## REVISED RESPONSE TO REQUEST FOR ADDITIONAL INFORMATION

### APR1400 Design Certification

Docket No. 52-046

**RAI No.:** 252-8299  
**SRP Section:** 03.07.02 – Seismic System Analysis  
**Application Section:** 3.7.2  
**Date of RAI Issue:** 10/19/2015

Figure 33. Comparison of Transfer Functions of 18085 Node at Plant Grade Elevation (S1 Soil Profile, Uncracked Concrete Stiffness Case)

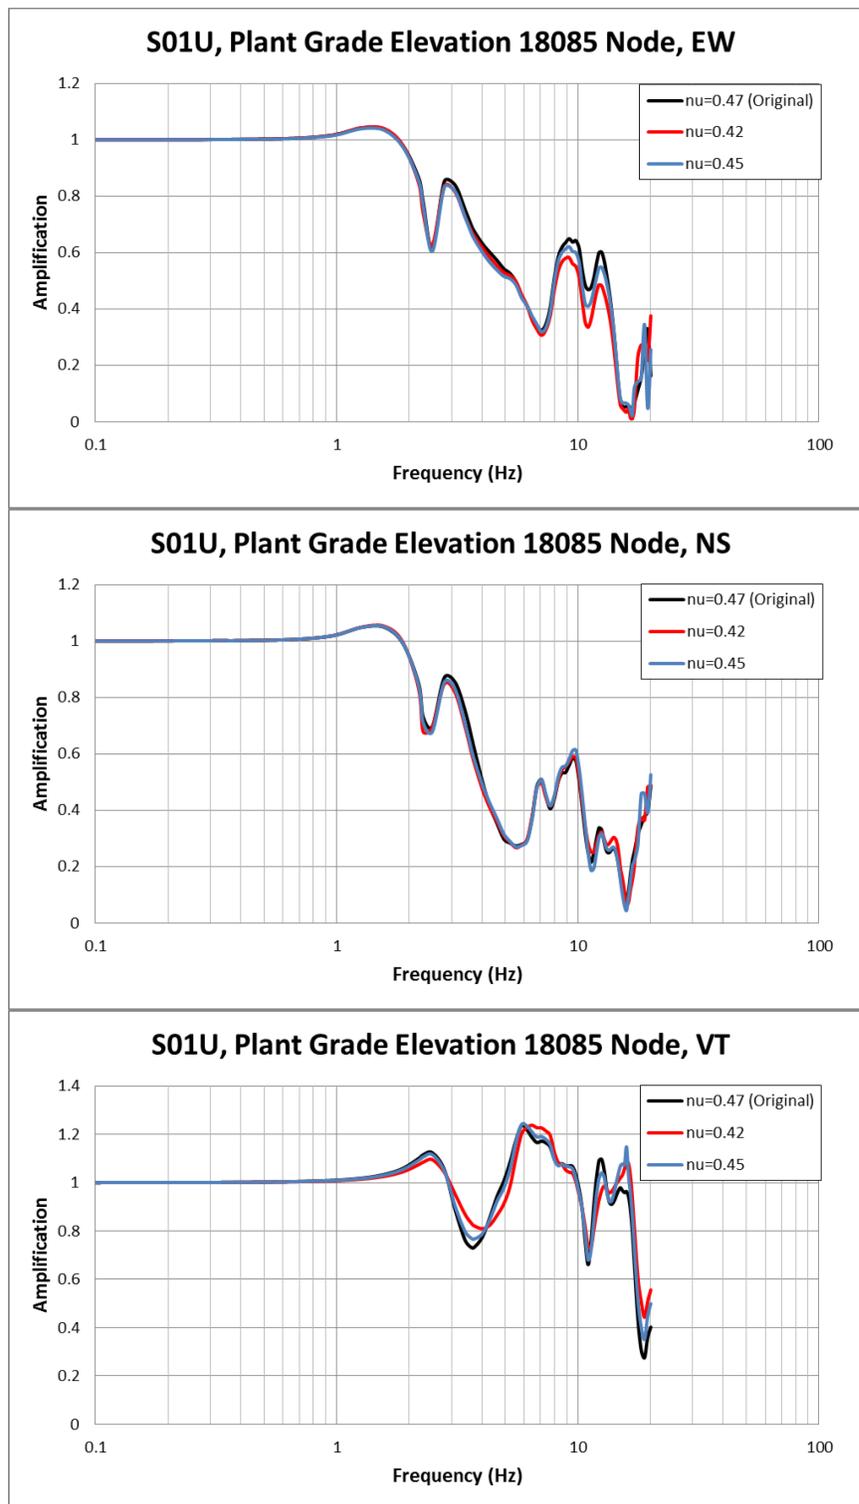
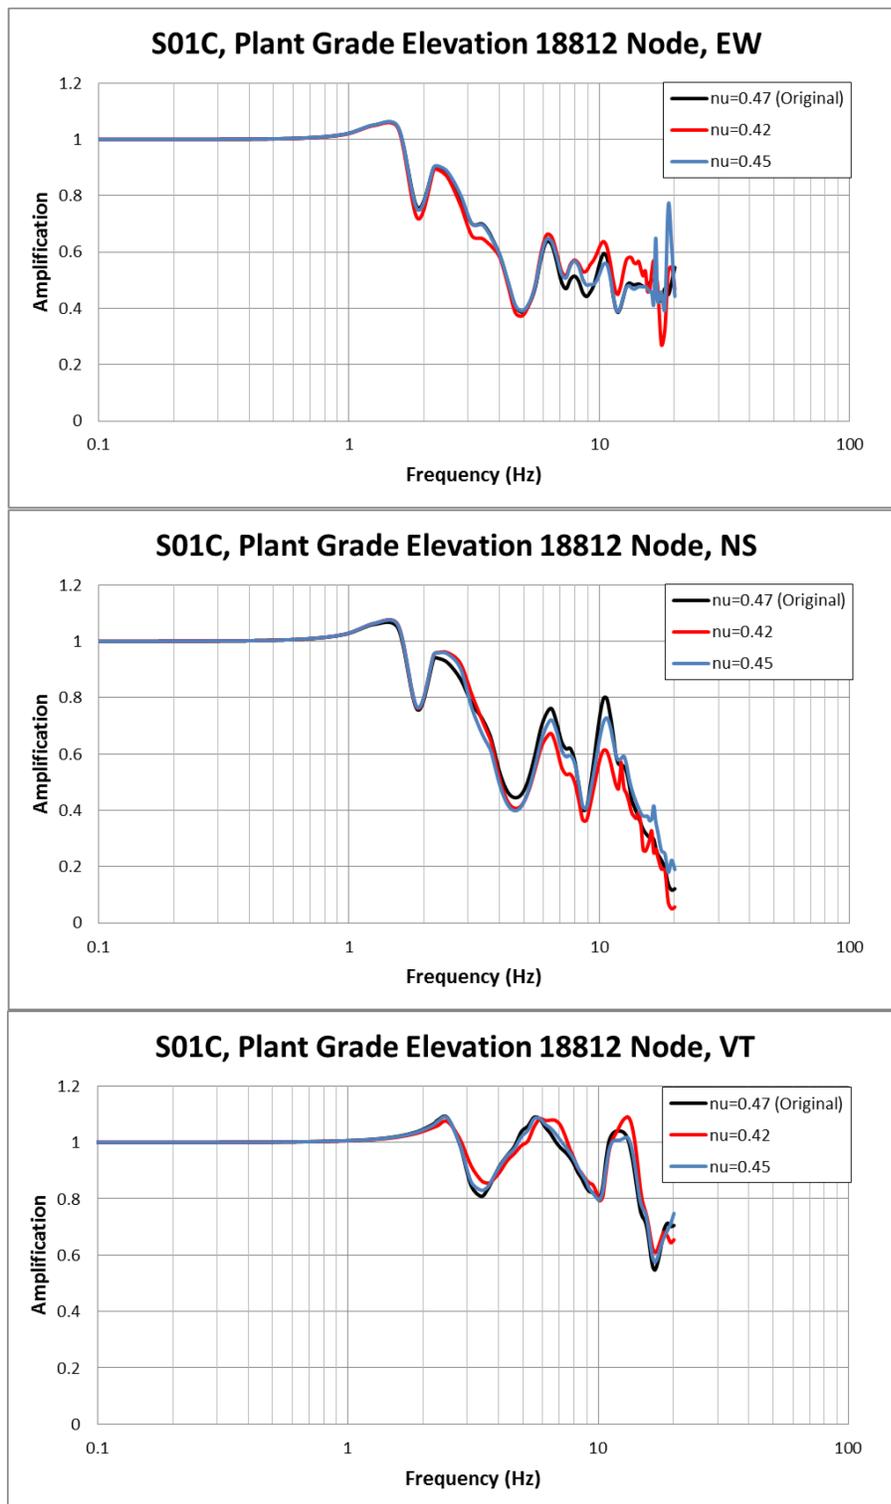
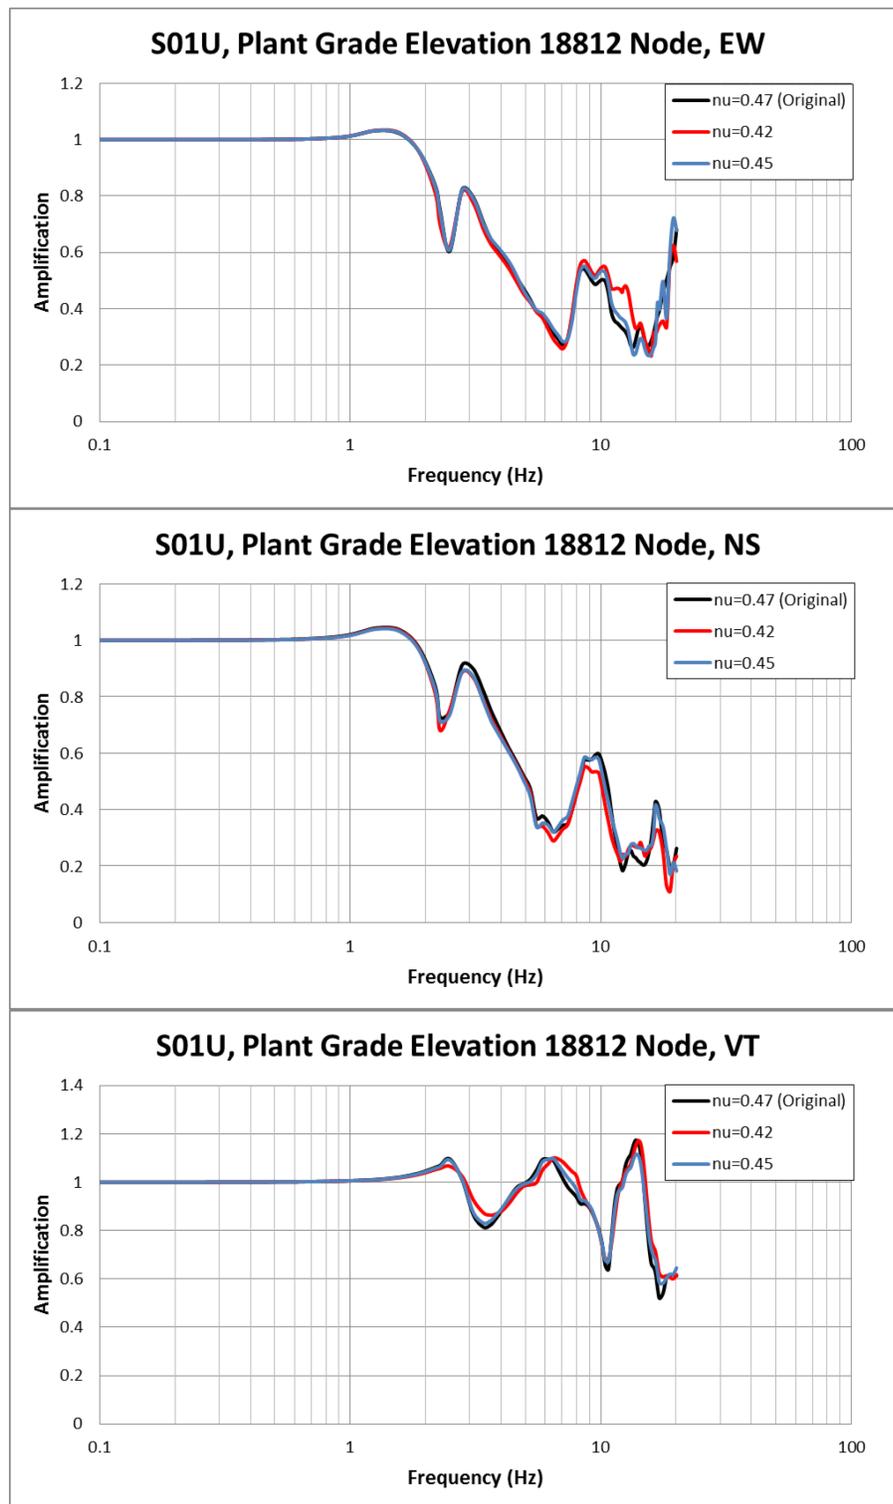
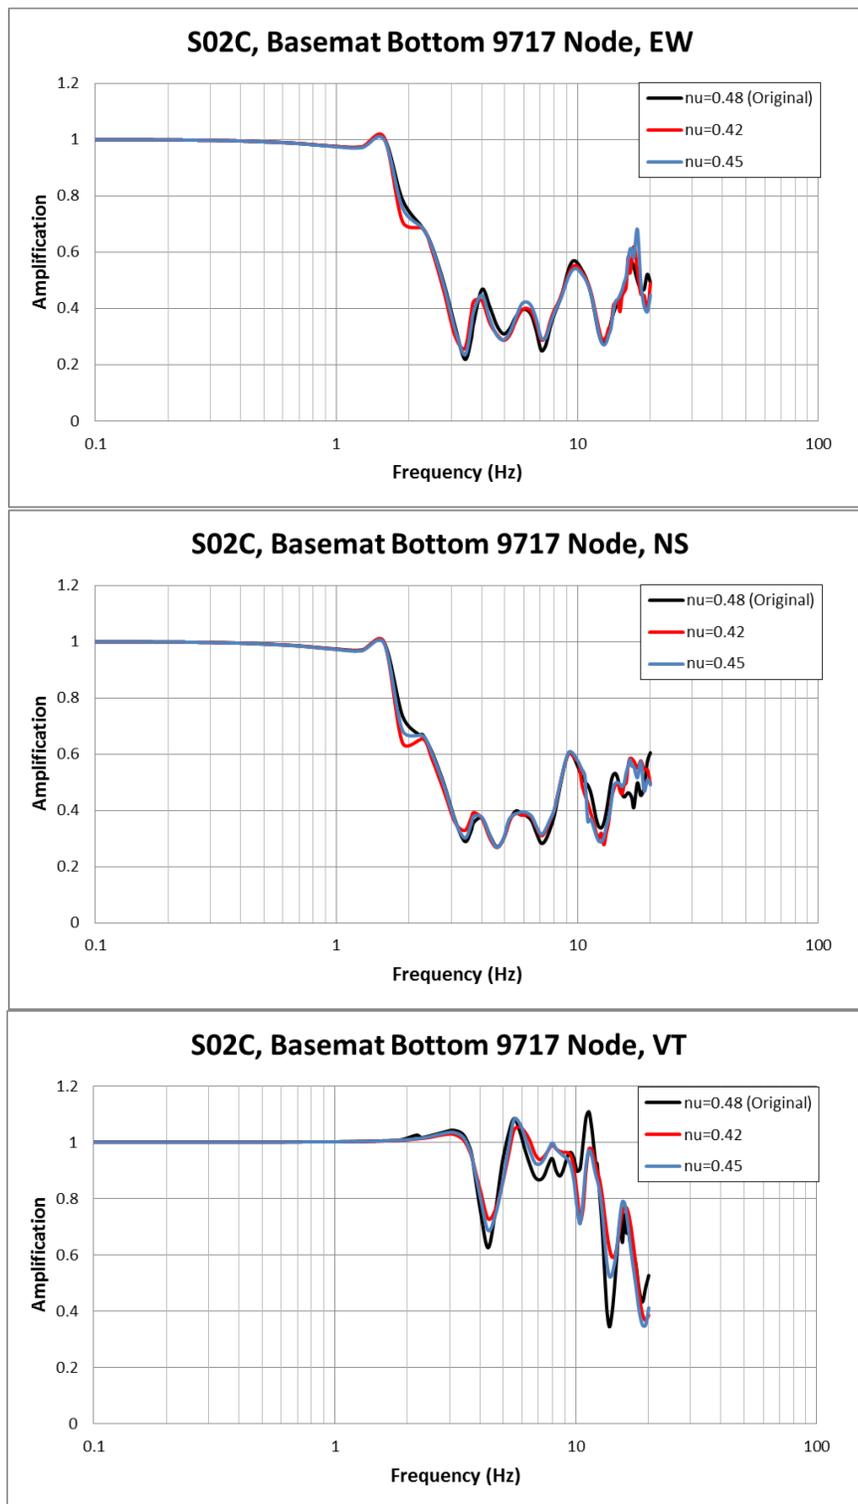
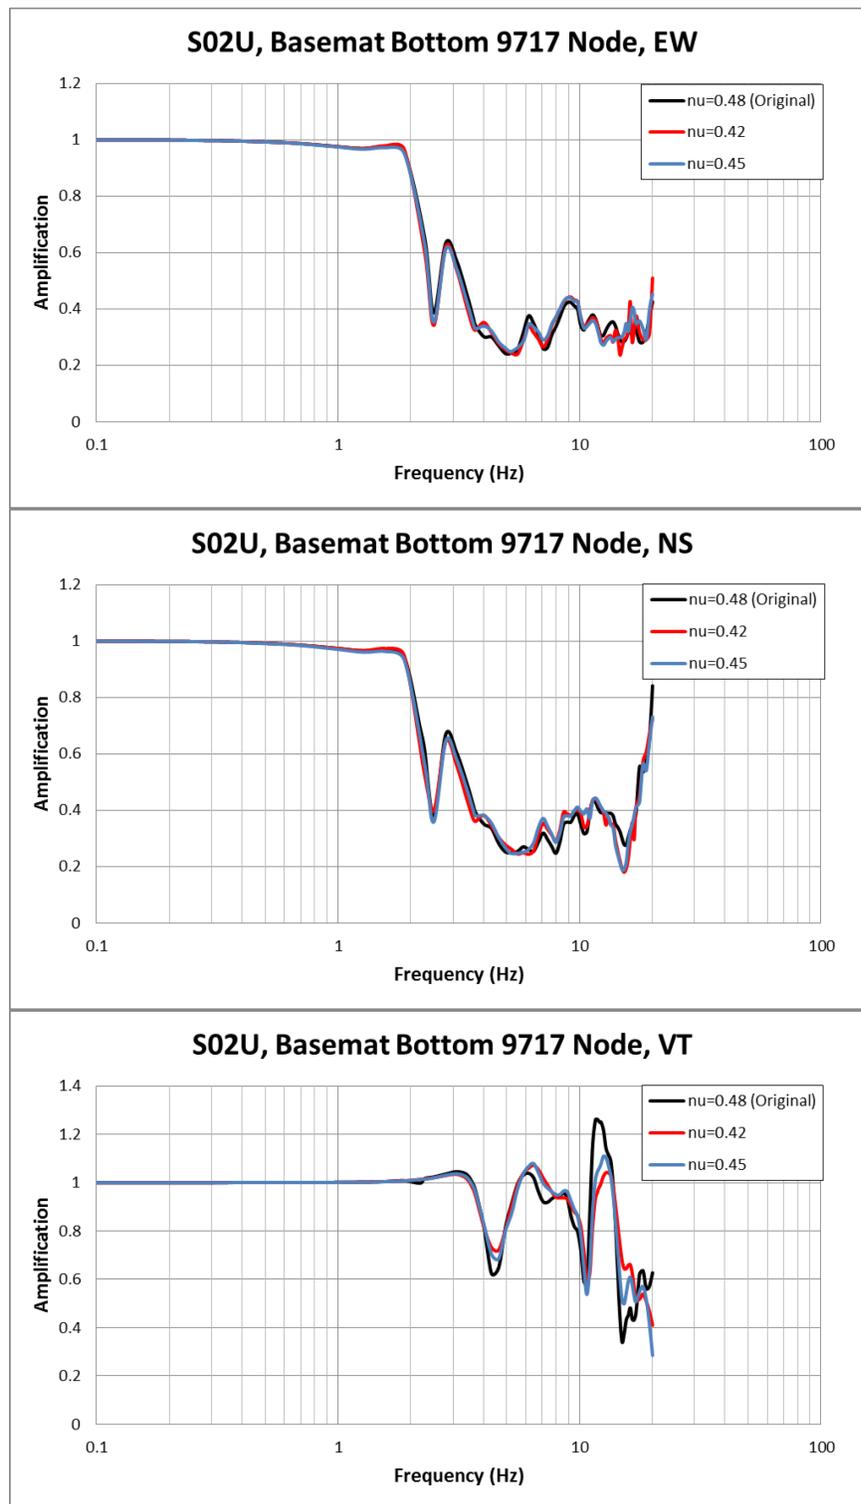
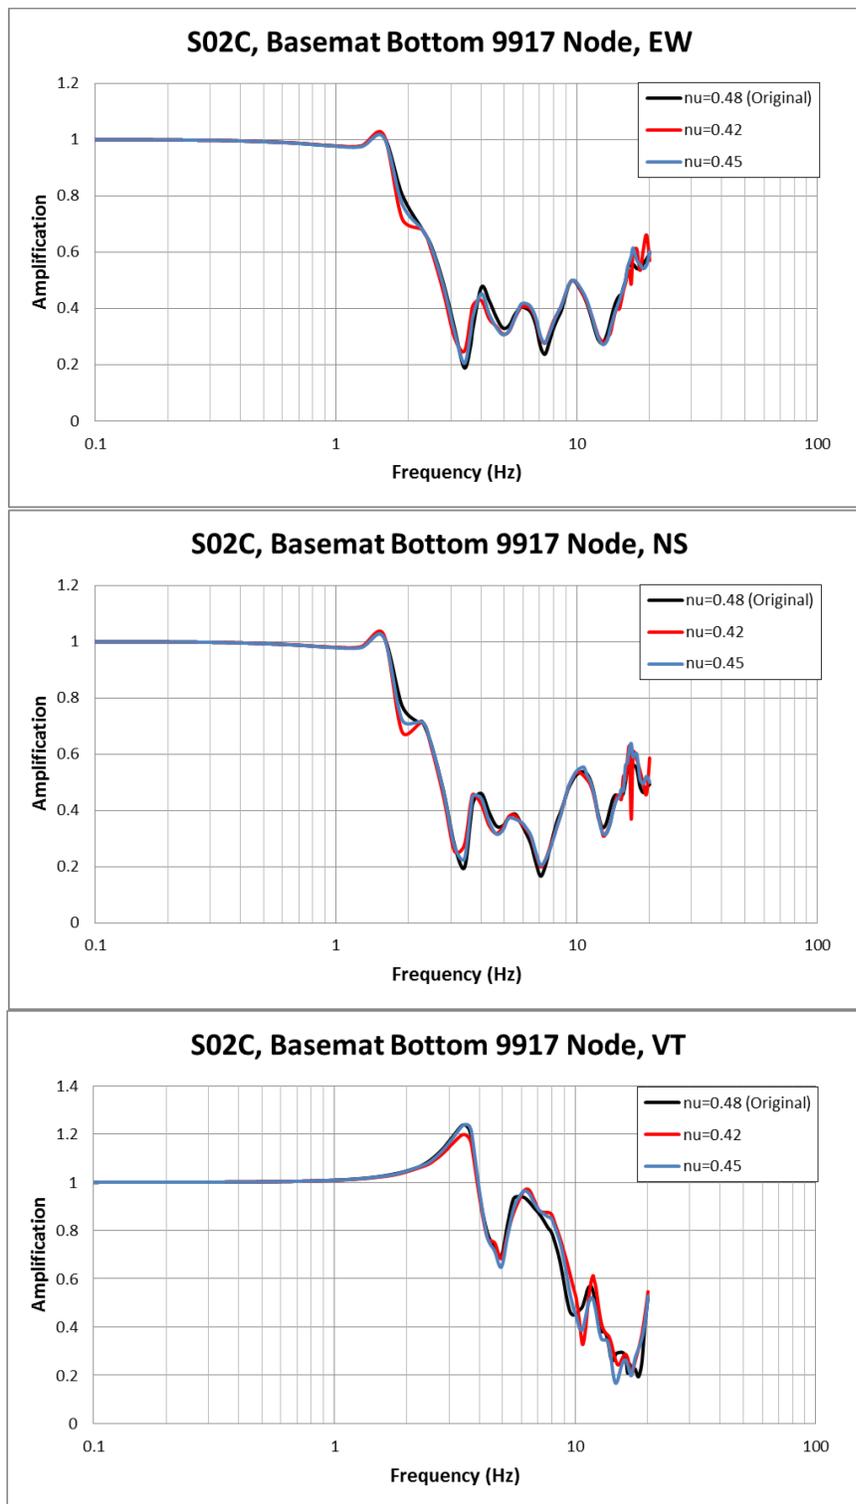
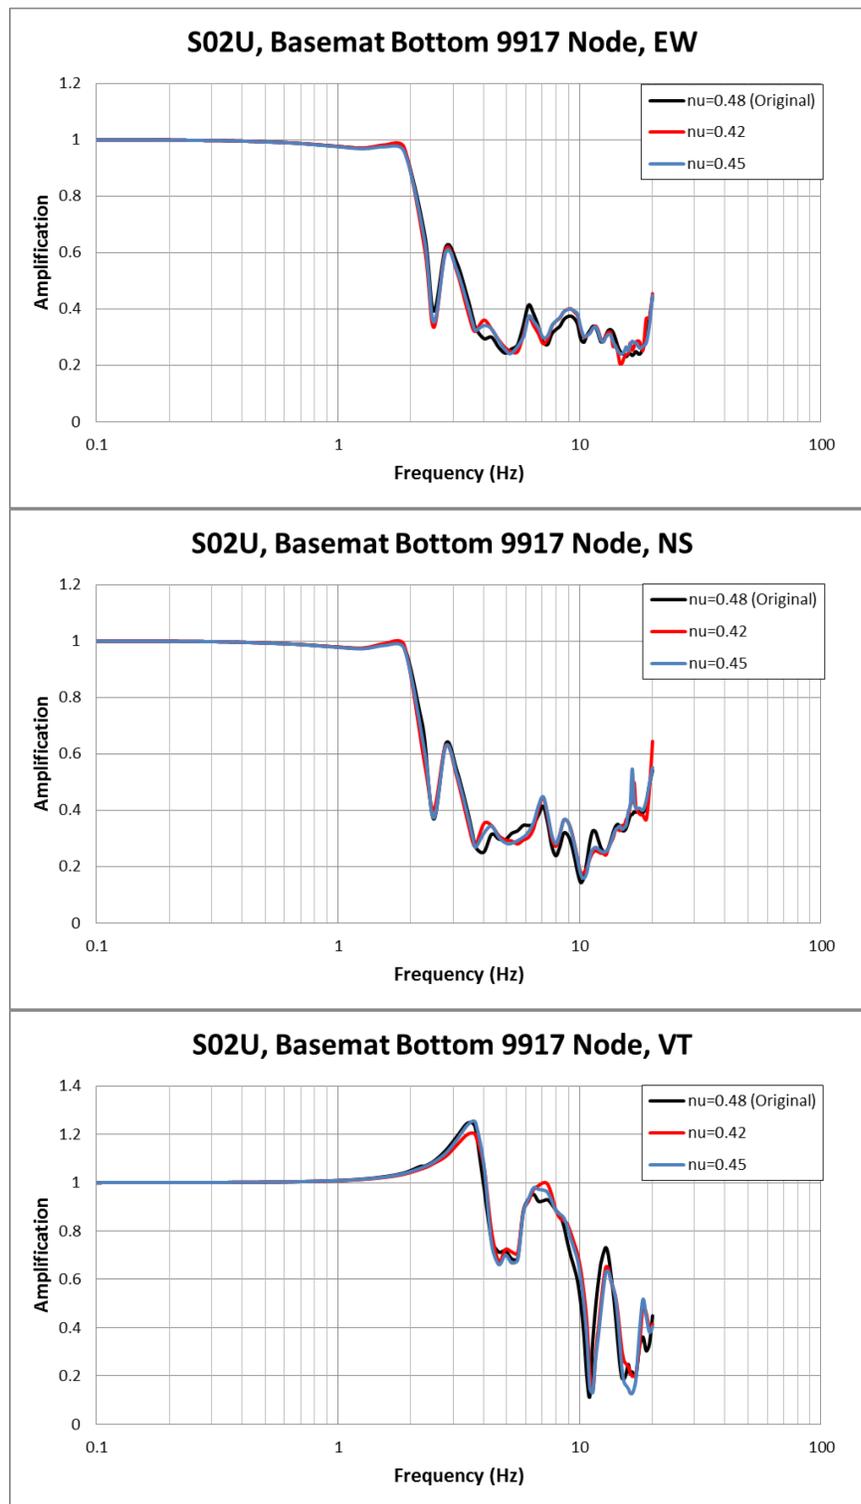
e) Poisson's Ratio Used in SSI Analyses

DCD Tables 3.7A-1 and 3.7A-2 show Poisson's ratios in the S1 and S2 soil profiles used for SSI analysis as great as 0.47 and 0.48 respectively. Based on staff experience, use of Poisson's ratio approaching these values may result in numerical instability of the SSI analysis results. Therefore, to assist the staff in evaluating the adequacy of the SSI analysis results based on the aforementioned soil profiles, the staff request the applicant to provide a demonstration (e.g. sensitivity study) that the assumed Poisson's ratio values do not produce numerical instabilities in the SSI results based on these profiles.

Using the modified soil profiles of S1 and S2, SSI analyses of NI models of both cracked and uncracked concrete stiffness cases are re-performed. Then, the transfer function results at NI basemat bottom and plant grade elevations obtained from the original SSI analyses and the re-performed SSI analyses in the sensitivity study are compared to judge the existence of numerical instabilities in the original SSI results. The locations of the selected nodes at basemat bottom and plant grade elevations using in the comparisons are provided in Figures 18 and 19. The comparisons of transfer function results for S1 and S2 soil profile cases are presented in Figures 20 through 51.

As shown in the comparisons of transfer functions presented in these figures, the transfer functions obtained from the original SSI analyses are quite similar and comparable to the transfer functions obtained from the sensitivity study re-performed SSI analyses. In addition, no abrupt changes or spurious peaks, which tend to indicate existence of

numerical sensitivities in the SASSI solutions, appear in the computed transfer functions of the original SSI analyses that have the maximum dynamic Poisson's ratio values of 0.47 and 0.48 as well as in the re-computed transfer functions that have the maximum dynamic Poisson's ratio values limited to 0.42 and 0.45. These results demonstrate that there is no numerical instabilities in the original SSI analysis results of the S1 and S2 soil profile cases.
